Serial Nr.: 10/644,946

AMENDMENTS TO THE DRAWINGS:

REMARKS

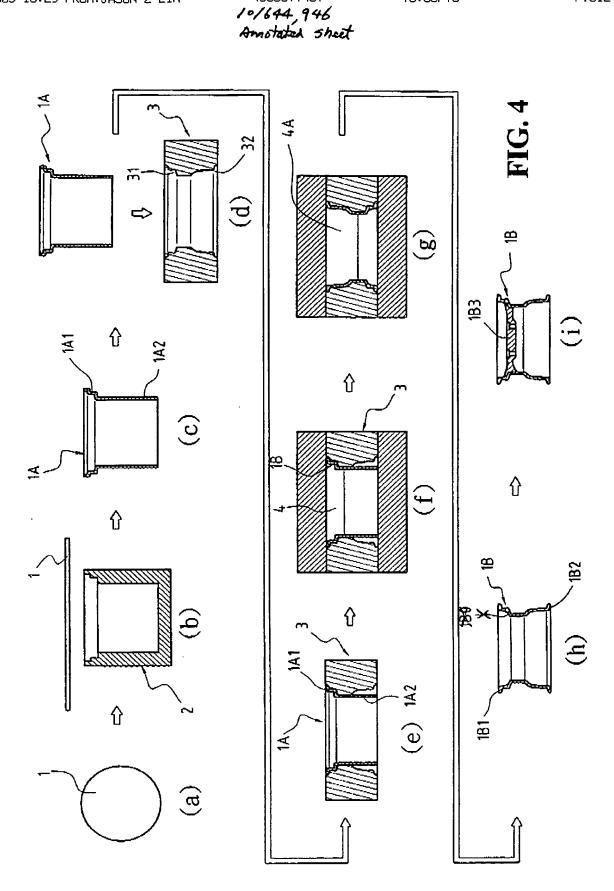
FIG. 4(h) is amended to delete symbol "1B0" as marked in the attached annotated sheet of drawing.

With regard to examiner's objection to the drawings, FIG. 4(h) has been amended

to delete the unnecessary reference symbol "1B0". The specification has been amended to

drawings should now be overcome. The annotated sheet of the amended drawing FIG.

4(h) is attached for approval. The replacement sheet will be submitted by US post office
